# Illustrated part list IPL update

**H562XP/XPG**

### Description of change

2. Clutch drum

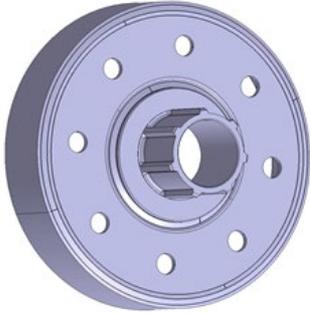
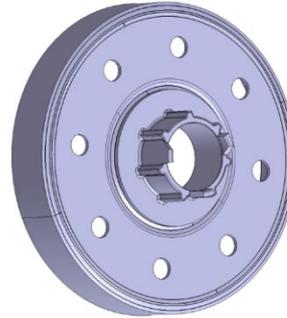
1. We have removed the label 535 05 80-01 on Clutch cover assy and added a moulded logo "Husqvarna". New colour: **Metallic Rough**.
2. New forged adapter has been implemented on the Clutch drum, the new Worm wheel has a new design due to this new adapter. The old Worm wheel 577 60 11-01 will **NOT** fit the new Clutch drum, and the new Worm wheel will **NOT** fit the old Clutch drum.
3. New Oil pump 505 19 99-09 with increased diameter has been introduced to fit the new Clutch drum. New colour: **Natural**.

1. Clutch cover assy 525 74 33-05 is fully exchangeable. New colour: **Metallic Rough**.
2. Clutch drum and Worm wheel are **NOT** exchangeable.
3. Oil Pump is fully exchangeable. New colour: **Natural**.  
Clutch drum assy kit 598 93 77-04 is fully exchangeable.
4. Ball bearing 525 43 42-04 is fully exchangeable with 525 43 42-03.  
Ball bearing 525 43 42-04 is **NOT** fully exchangeable with 505 13 35-03.
5. Crankcase assy 575 38 02-23 and Shortblock 580 66 37-12 are fully exchangeable.  
New colour: **Metallic Rough**.
6. Protective cap is **NOT** fully exchangeable. **NOTE:** Only for use on new Crankcase 575 38 02-23 and Shortblock 580 66 37-12.

575 26 10-08

575 26 10-05/-06
